Form 3160-5
(June 2019)UNITED STATES
DEPARTMENT OF THE INTERIOR
BUREAU OF LAND MANAGEMENTFORM APPROVED
OMB No. 1004-0137
Expires: October 31, 2021**SUNDRY NOTICES AND REPORTS ON WELLS**
Do not use this form for proposals to drill or to re-enter an abandoned well. Use Form 3160-3 (APD) for such proposals.

8. Well Name and No. MIDNIGHT HOUR 10 FED COM/714H

9. API Well No. 30-015-49811

EOG respectfully requests an amendment to our approved APD for this well to reflect the following changes:

WELL LOCATION AND ACREAGE DEDICATION PLAT

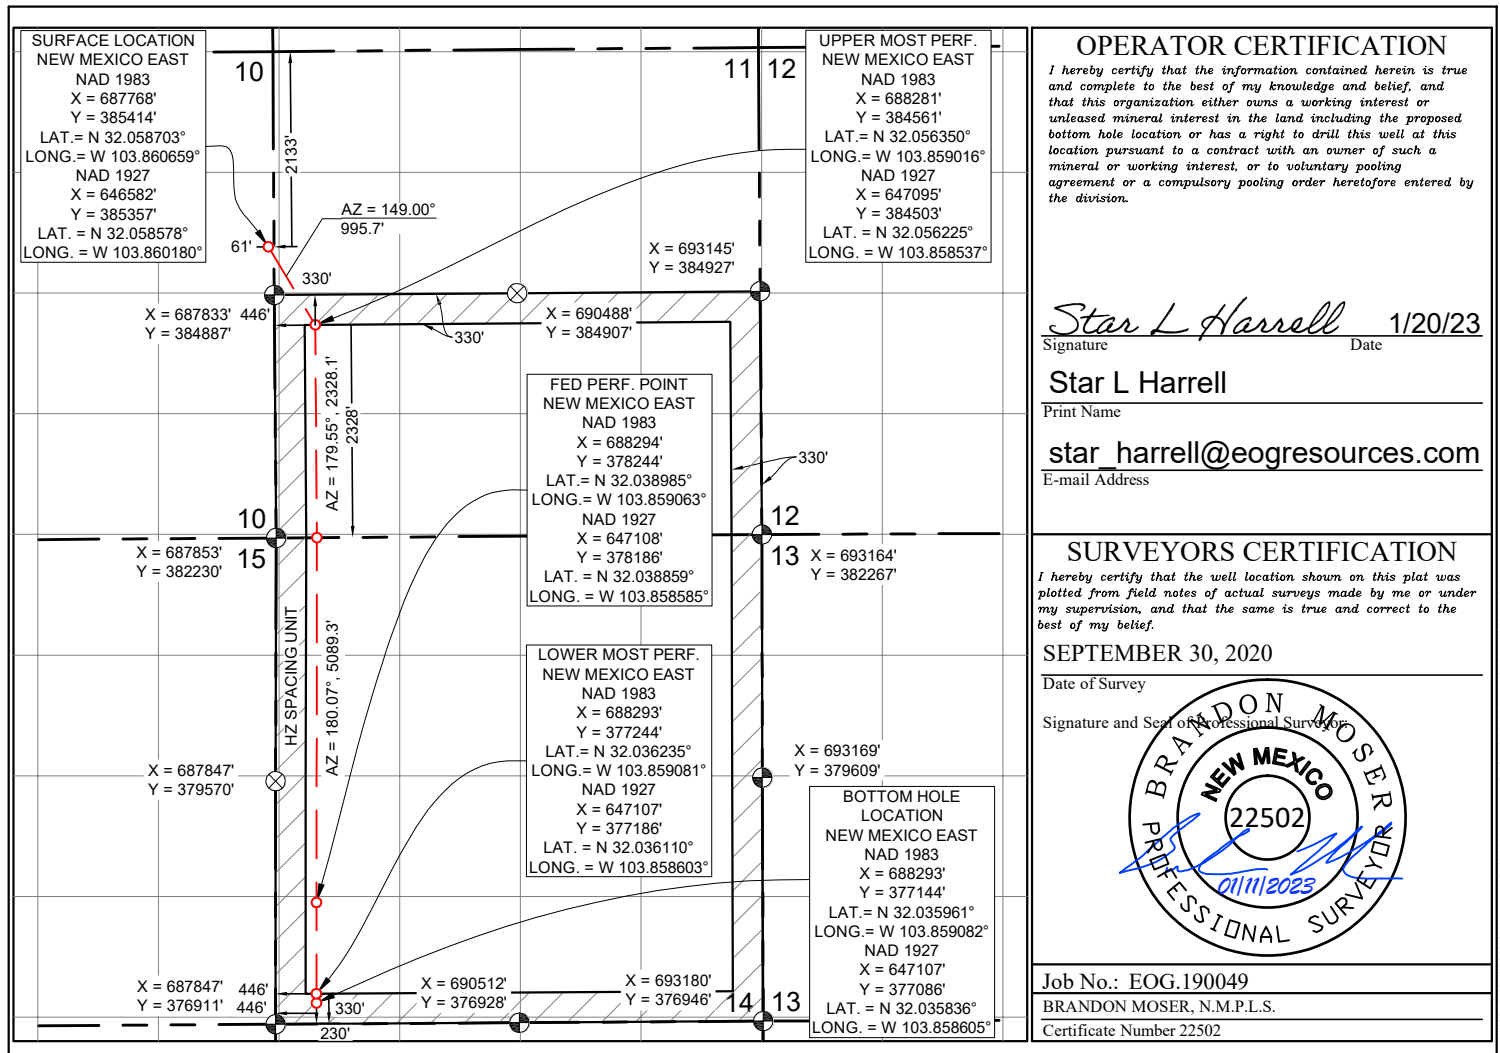
Change BHL from T-26-S, R-30-E, Sec 14, 230' FSL, 660' FWL, Eddy Co., NM, to T-26, R-30, Sec 14, 230 FSL, 446 FWL, Eddy Co., N.M.

UL or lot no.	Section	Township	Range	Lot Idn	Feet from the	North/South line	Feet from the	East/West line	County
M	14	26 S	30 E		230	SOUTH	446	WEST	EDDY
